DART SERVICE INSTRUCTION

TO AMEND INSTALLATION INSTRUCTIONS IIN-D407-781-2 REV. A OR LATER APPROVED REVISION
AND INSTRUCTIONS FOR CONTINUED AIRWORTHINESS ICA-D407-781 REV. 3 OR LATER REVISION

A	NEW ISSUE		13.04.08
REV.		DESCRIPTION	BY DATE
DESIGN			
DRAWN			
CHECKED			
MFG. APPR.	N/A		
APPROVED			
DE APPR.			
DATE	13.04.08		
		DART AEROSPACE LTD HAWKESBURY, ONTARIO, CANADA	
		DRAWING NO. DSI 9649	REV. A SHEET 1 OF 2
		TITLE ALTERNATE INSTALL	SCALE NTS
COPYRIGHT © 2013 BY DART AEROSPACE LTD. THIS DOCUMENT IS PRIVATE AND CONFIDENTIAL AND IS SUPPLIED ON THE EXPRESS CONDITION THAT IT IS NOT TO BE USED FOR ANY PURPOSE OR COPIED OR COMMUNICATED TO ANY OTHER PERSON WITHOUT WRITTEN PERMISSION FROM DART AEROSPACE LTD.

**FIGURE 1 - D3879-1 BAGGAGE COMPARTMENT WALL
PROTECTOR - ALTERNATE INSTALLATION**

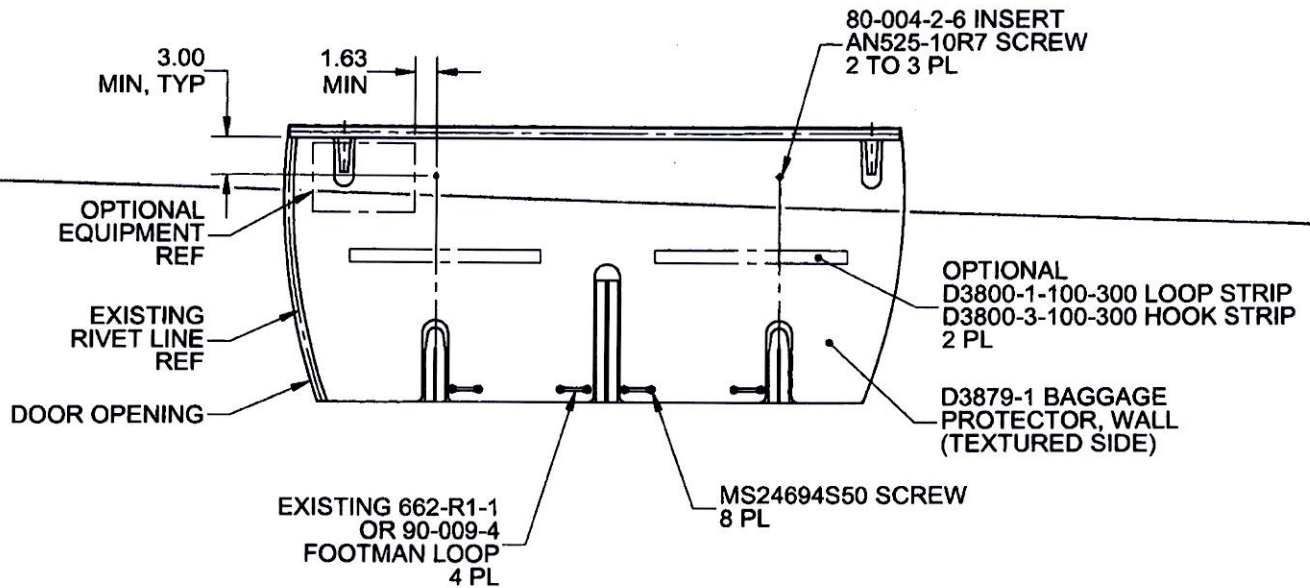
In some aircraft, the top portion of the D206-781-041 Baggage Compartment Wall Protector Kit cannot be installed as indicated in IIN-D407-781-2. The purpose of this DSI is to provide an alternate mounting method to fasten the top portion of the D206-781-041 Baggage Compartment Wall Protector Kit.

It is acceptable to replace qty(2) D3930-1 Clips with qty(2) 80-004-2-6 Inserts. Locate and mark location of the two attachment holes on the baggage compartment wall as shown in Figure 1 of this service instruction. Install 80-004-2-6 Inserts at the marked locations in accordance with Section 3-2-12 of BHT-206-SRM-1. It is acceptable to trim the wall protectors to accommodate optional equipment or transfer attachment holes to the wall protector and install the optional equipment on top of the wall protector with longer fasteners.

Amend the D206-781-041 Baggage Compartment Wall Protector Kit parts list as follows:

Qty -061	Qty -031	Qty -041	Part Number	Description
X			D206-781-061	BAGGAGE COMPARTMENT PROTECTOR KIT (FLOOR AND WALL)
1	X		D206-781-031	BAGGAGE COMPARTMENT FLOOR PROTECTOR KIT
1		X	D206-781-041	BAGGAGE COMPARTMENT WALL PROTECTOR KIT
		2	AN525-10R7	SCREW
		2	80-004-2-6	INSERT
